ADDENDUM

PROJECT: Lincoln Public Schools
Security and Technology Ready Facilities
Project H
Lincoln, Nebraska

AD-1

PROJECT #: DDI No. 14-0077 / LPS Bid No. 7636-H

Drawing #
303.T00.D.1

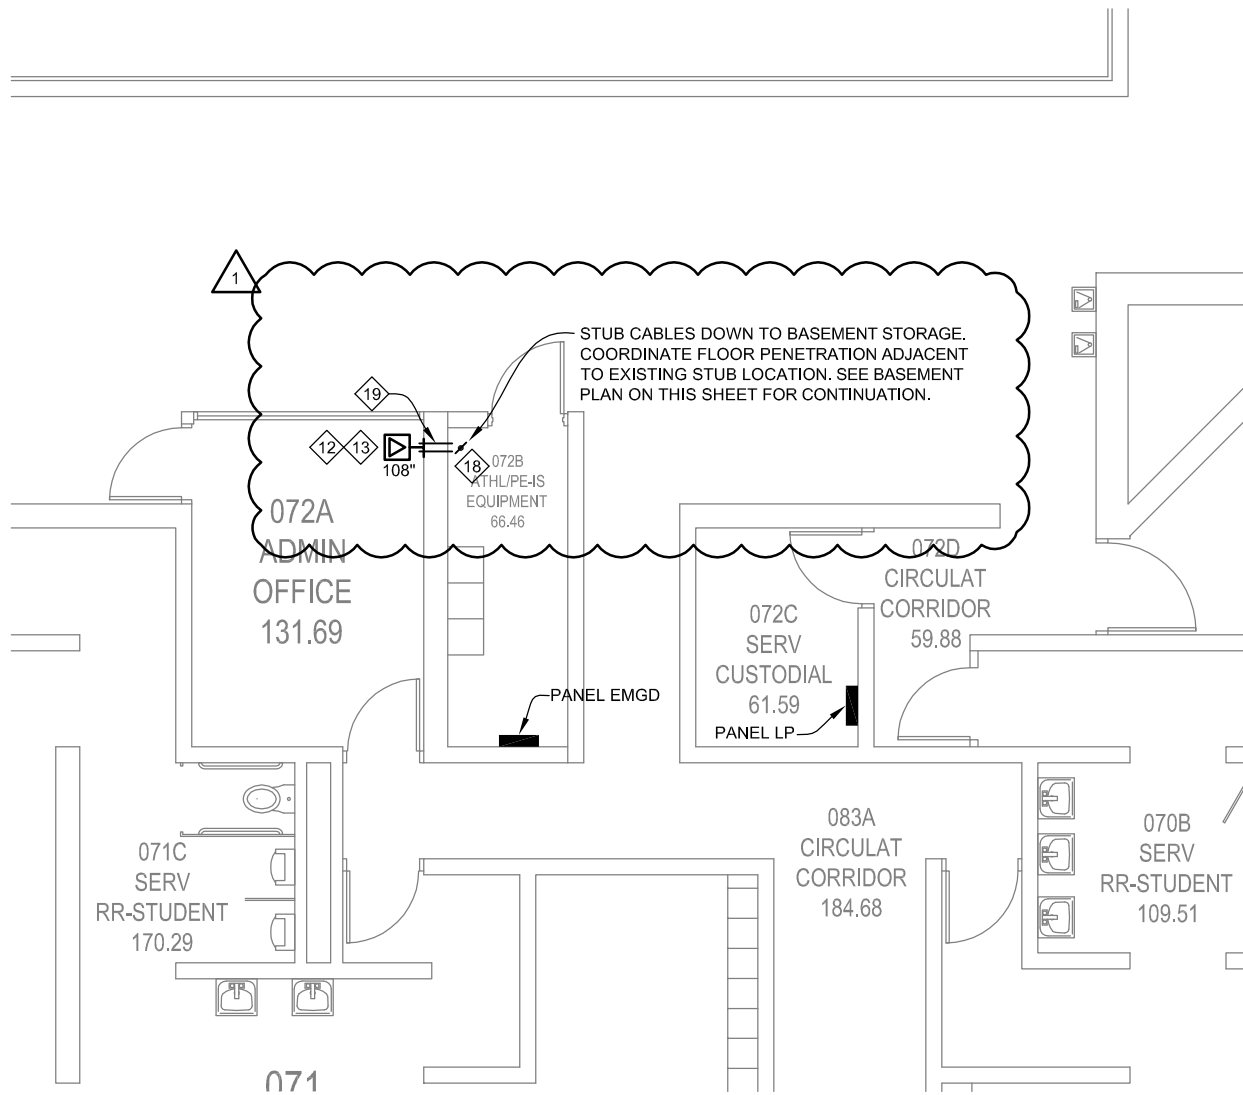
In reference to Sheet 303.T00.D, see attached sketches 303.T00.D.1 through 303.T00.D.3 for revisions.

From Sheet:	303.T00.E	for CA use:
Drawing #	303.T00.E.1

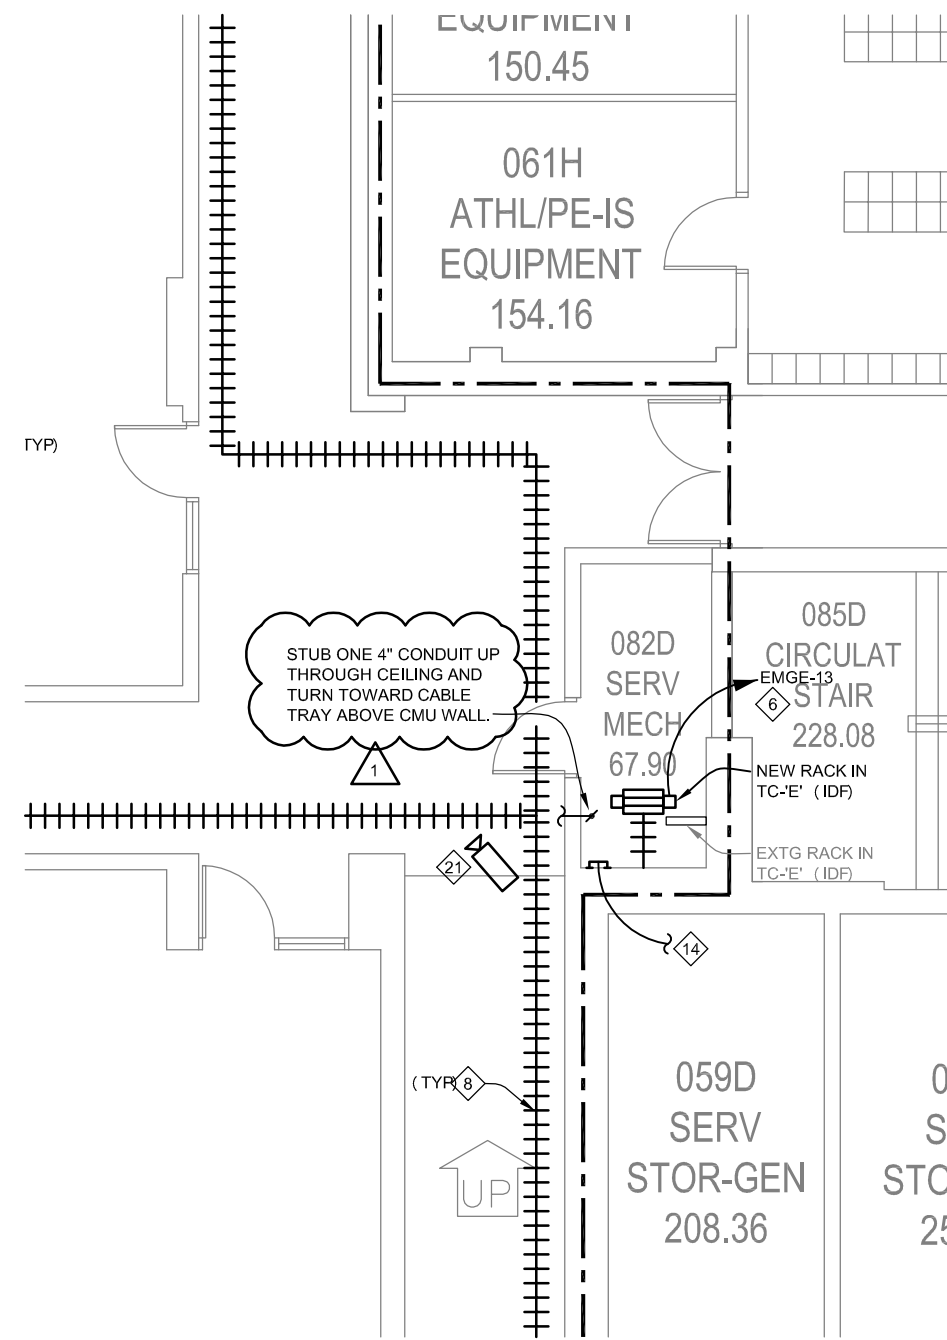
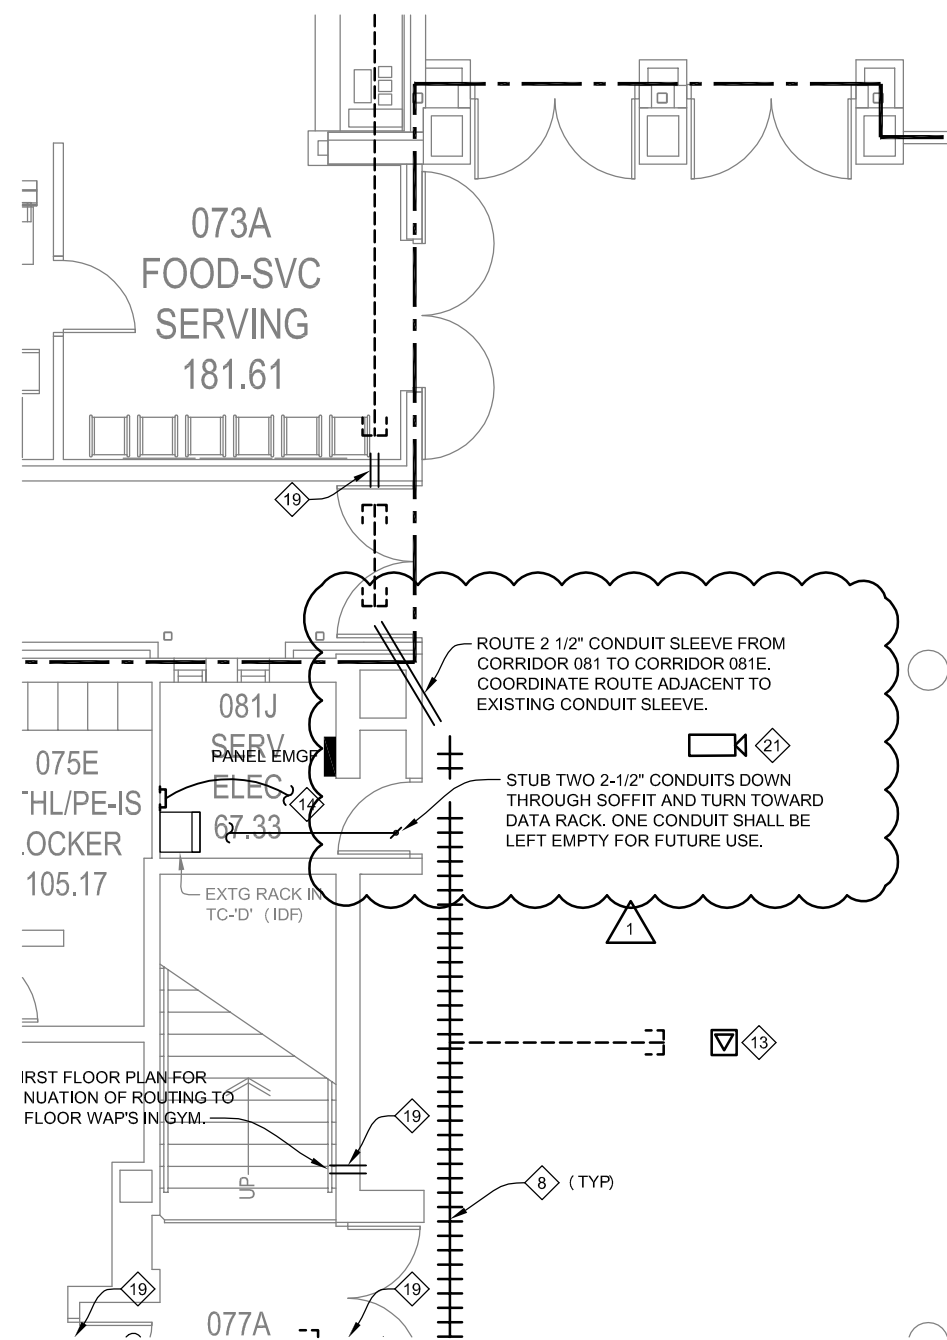
In reference to Sheet 303.T00.E, see attached sketch 303.T00.E.1 for revisions.

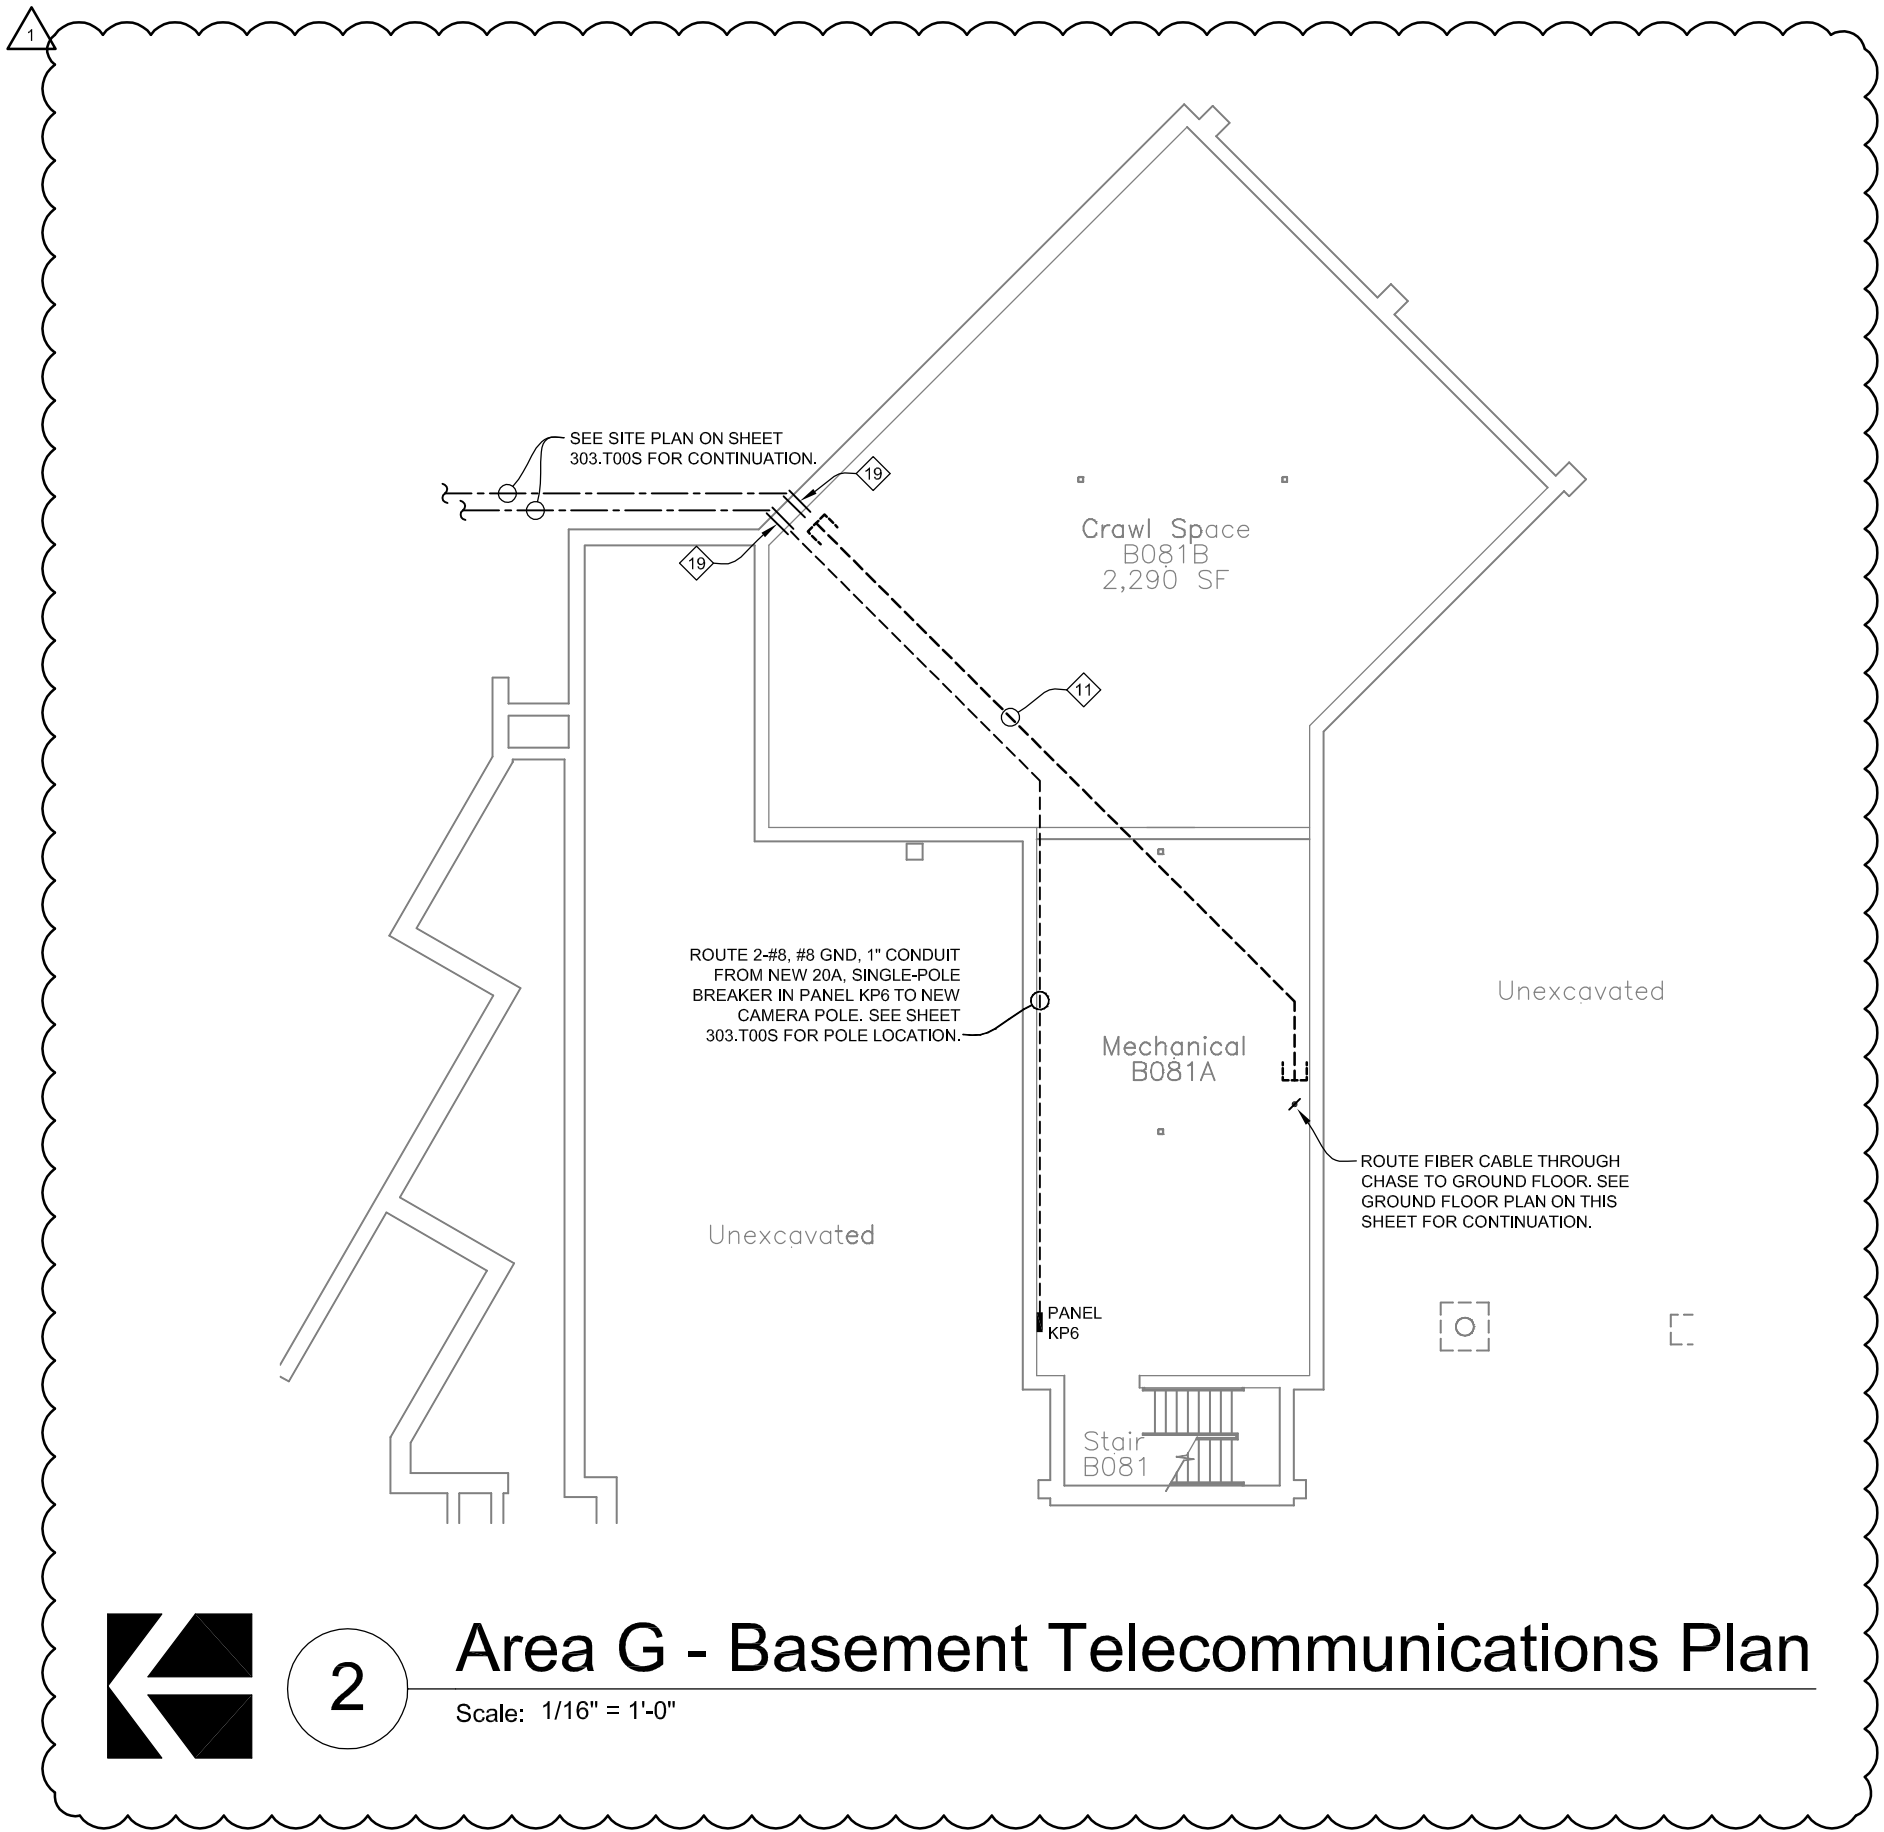
In reference to Sheet 303.T00.F, see attached sketch 303.T00.F.1 for revisions.

From Sheet:	303.T00.G	for CA use:
Drawing #	303.T00.G.1

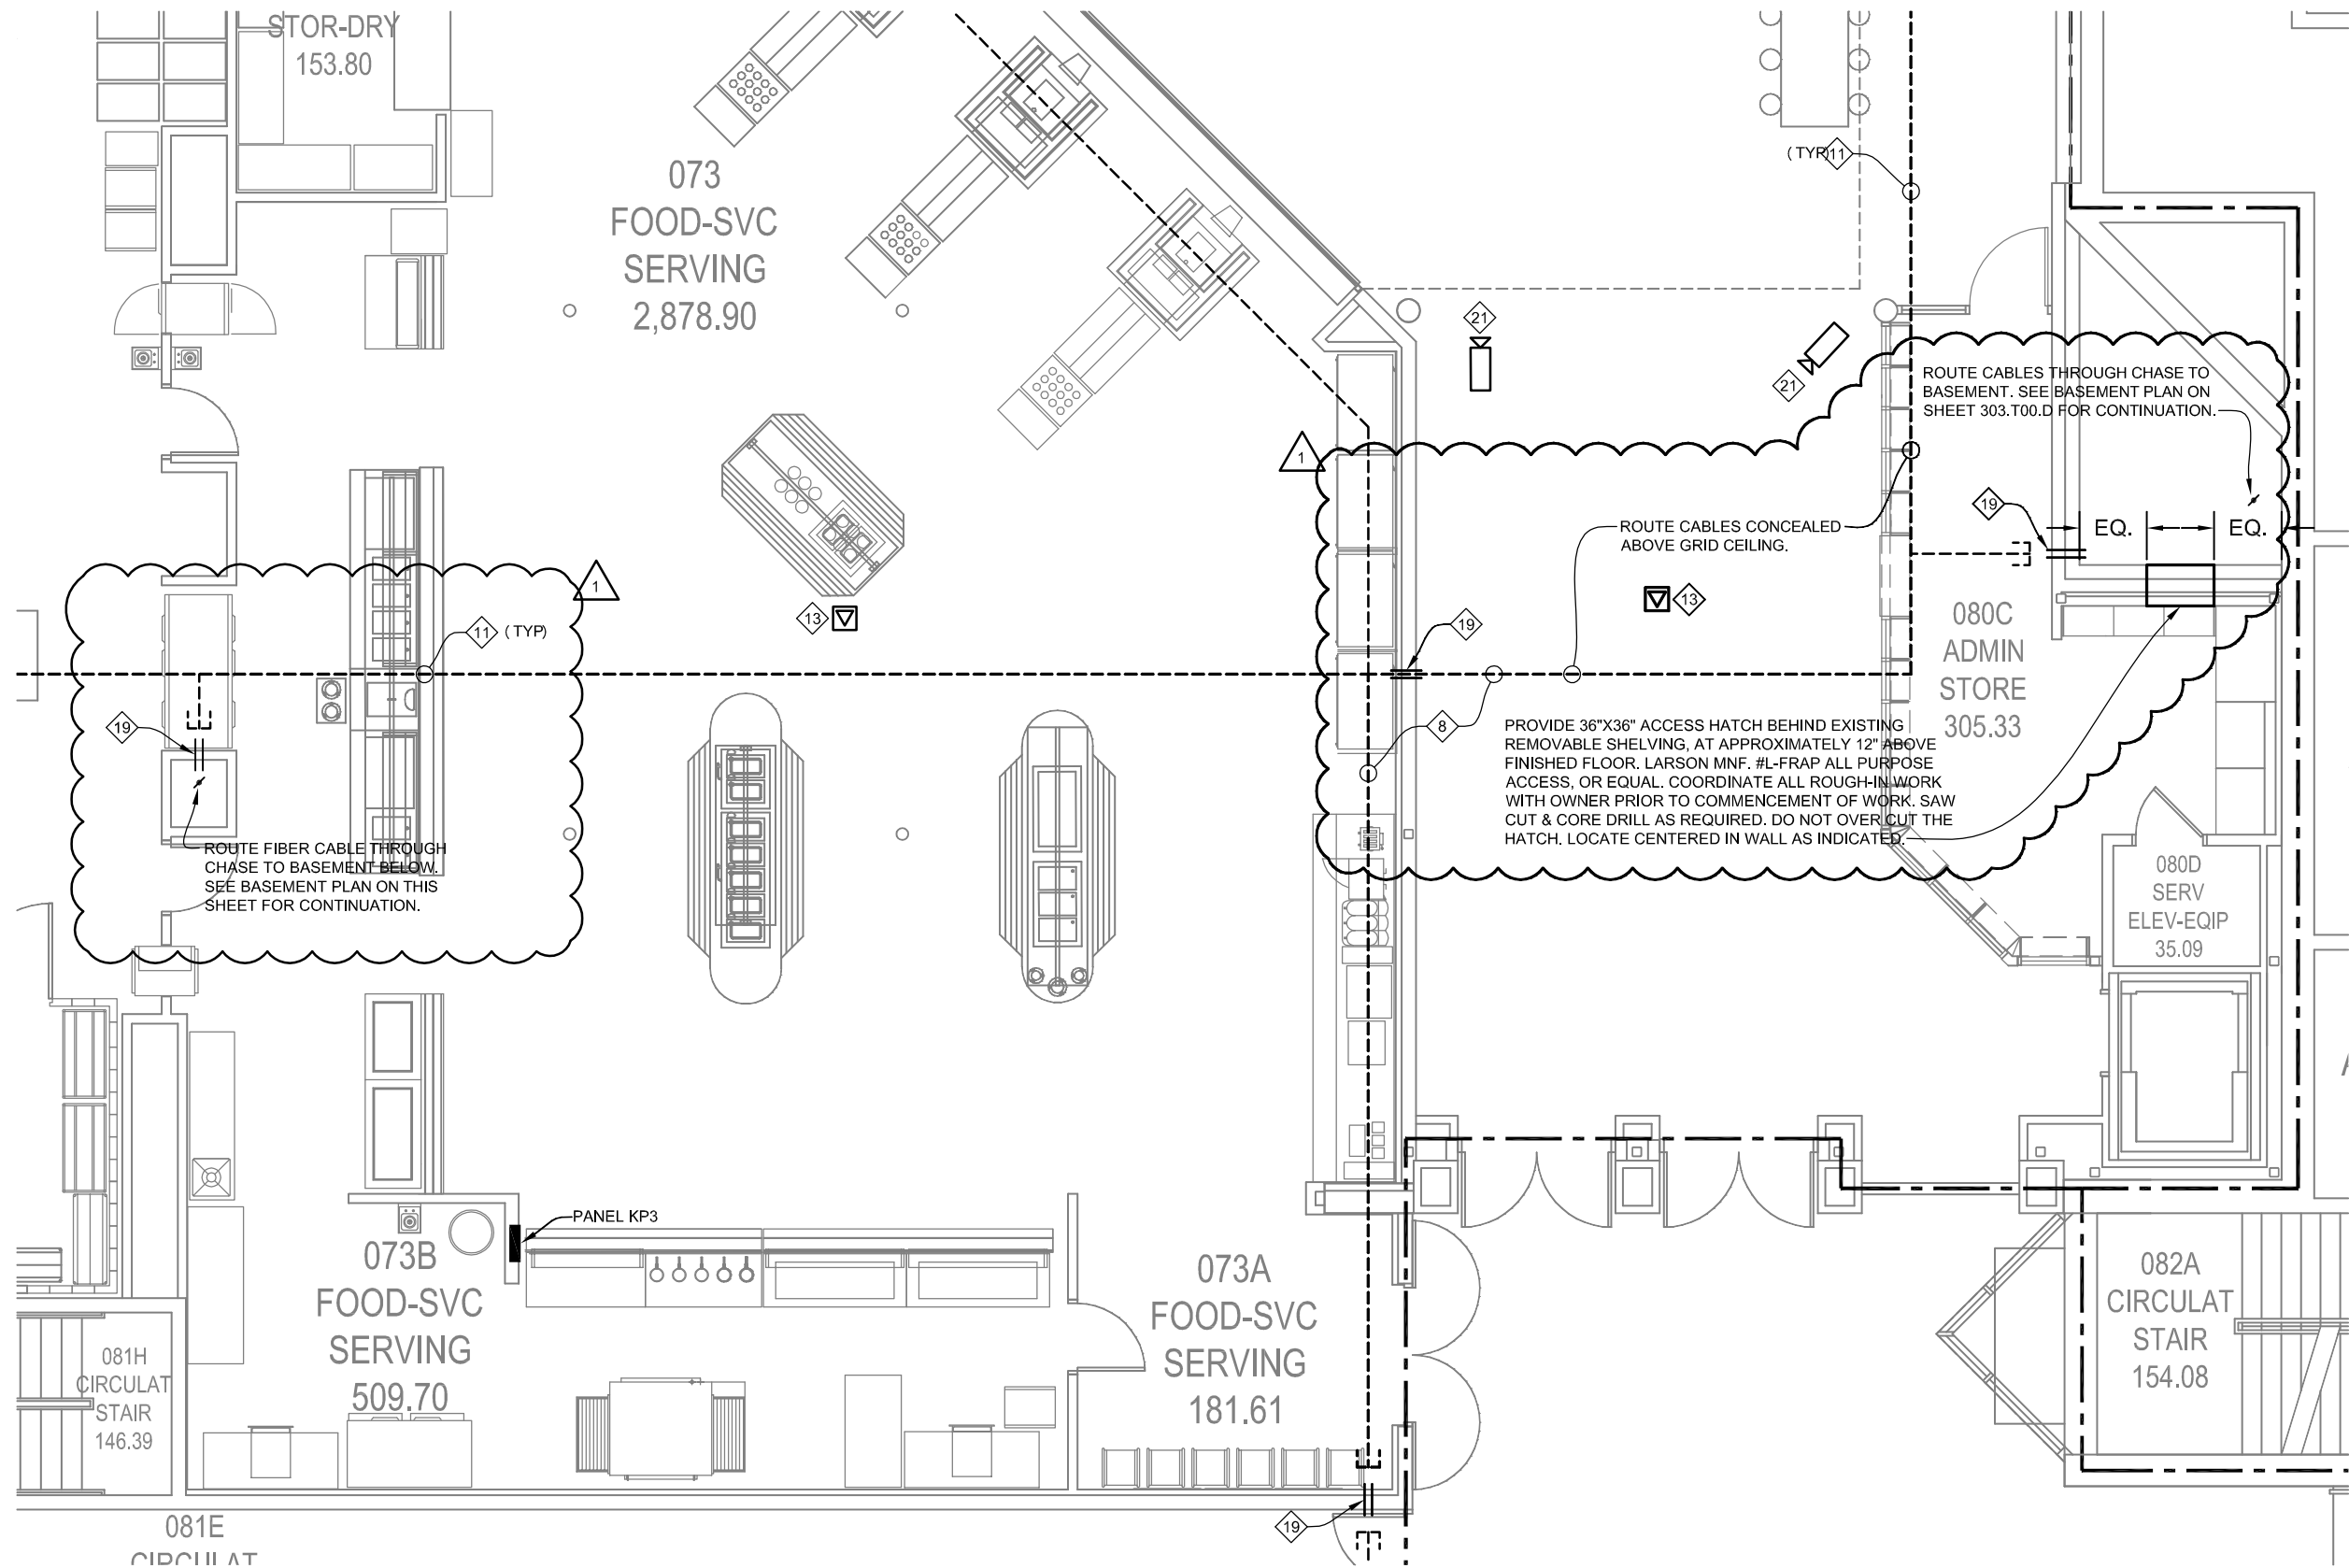
In reference to Sheet 303.T00.G, see attached sketch 303.T00.G.1 and 303.T00.G.2 for revisions.
